Appendix N

Responses to Comments on the Draft Environmental Impact Statement

Please find written comments submitted by the "Teamsters National Pipeline Labor Management Cooperation Trust" on the FERC's "Draft Environmental Impact Statement for the Venture Global LNG and Venture Global CP Express Projects" (**Docket Nos. CP22-21-000 and CP22-22-000**).

Figure 1. Environmental injustice analysis for CP2 LNG export terminal and CP Express pipeline, using the threshold method for identifying Census Block Groups of environmental justice concern. Census data is from the 2016 ACS.

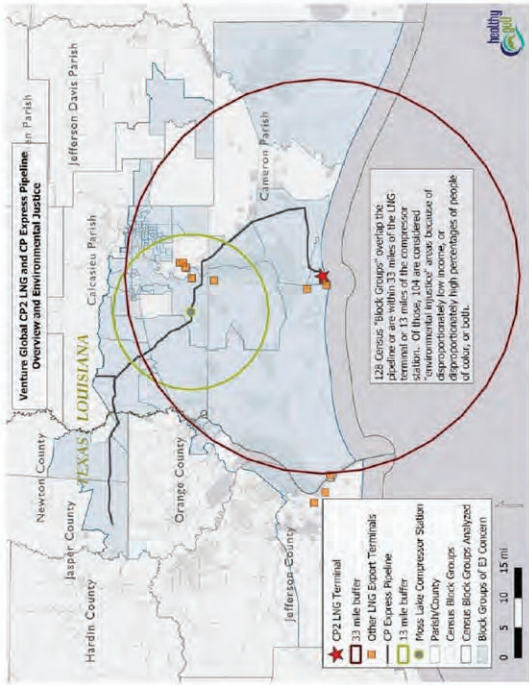
²⁰¹ See Fig. 1. Figure 1 features a 13-mile radius from the compressor station.

CO4-40: As discussed in section 4.10.10.1 of the EIS, FERC follows the recommendations set forth in EPA’s Federal Interagency Working Group on Environmental Justice and NEPA Committee’s publication, *Promising Practices for Environmental Justice Methodologies in NEPA Reviews* (Promising Practices (Promising Practices), which provides methodologies for conducting environmental justice analyses throughout the NEPA process.
